# ADDENDUM NO. 1

**January 11, 2023**

**The Riviera Club Aquatics Center  
5640 North Illinois Street  
Indianapolis, IN 46208**

# **ADDENDUM NO. 1**

Aquatics Center  
 FIRST FLOOR INTERIOR FINISH PLAN  
 IN1A1

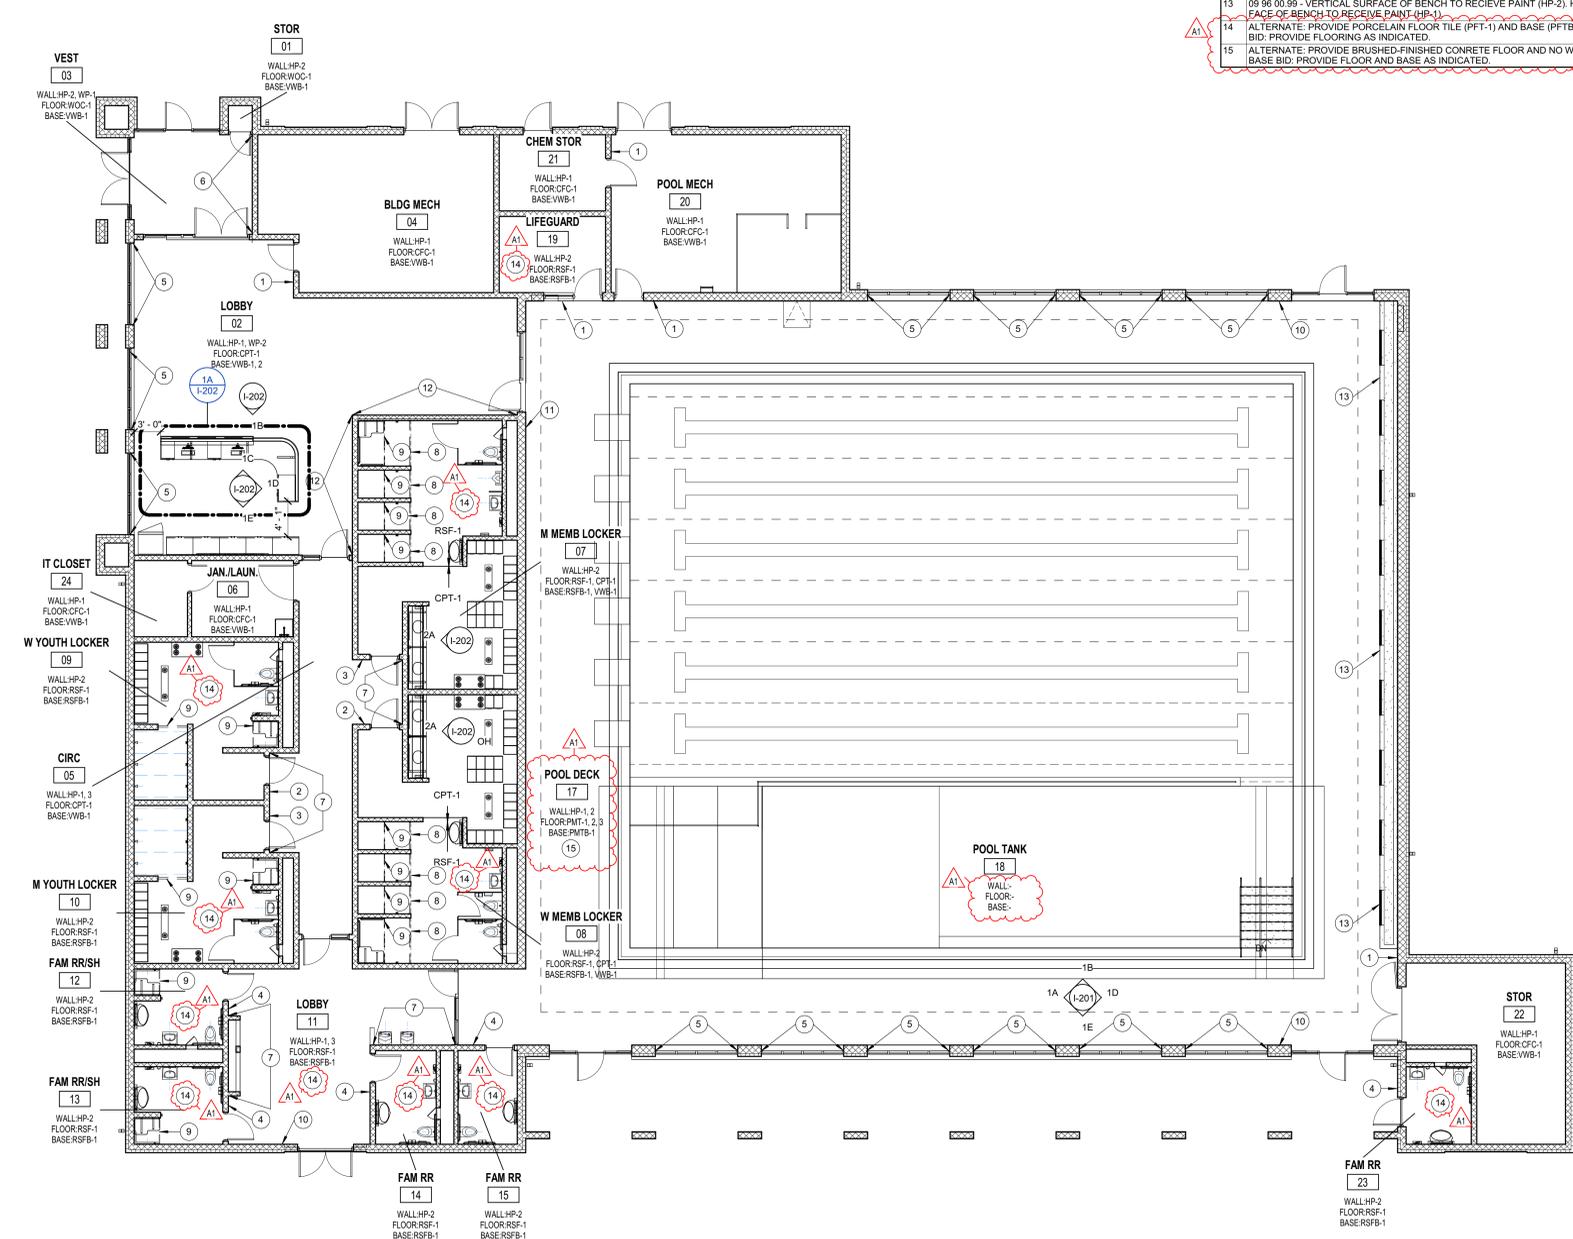
| 14 | ALTERNATE: PROVIDE PORCELAIN FLOOR TILE (PFT-1) AND BASE (PFTB-1). BASE BID: PROVIDE FLOORING AS INDICATED.                                 |
| 15 | ALTERNATE: PROVIDE BRUSHED-FINISHED CONCRETE FLOOR AND NO WALL BASE. BASE BID: PROVIDE FLOOR AND BASE AS INDICATED.                         |

- a. Base Bid: Provide resinous flooring and base in Member, Youth and Family Restrooms and Life Guard Room as described in the I-Series Drawings and spec section 096723.17.
- b. Alternate Bid: Provide Porcelain tile flooring and base in Member, Youth and Family Restrooms as described in the I-Series Drawings and spec section 093000.

- a. Base Bid: Provide Porcelain Mosaic Tile as described in the I-Series Drawings and Specifications
- b. Alternate Bid: Provide Brushed-Finished Concrete Floor and No Wall Base
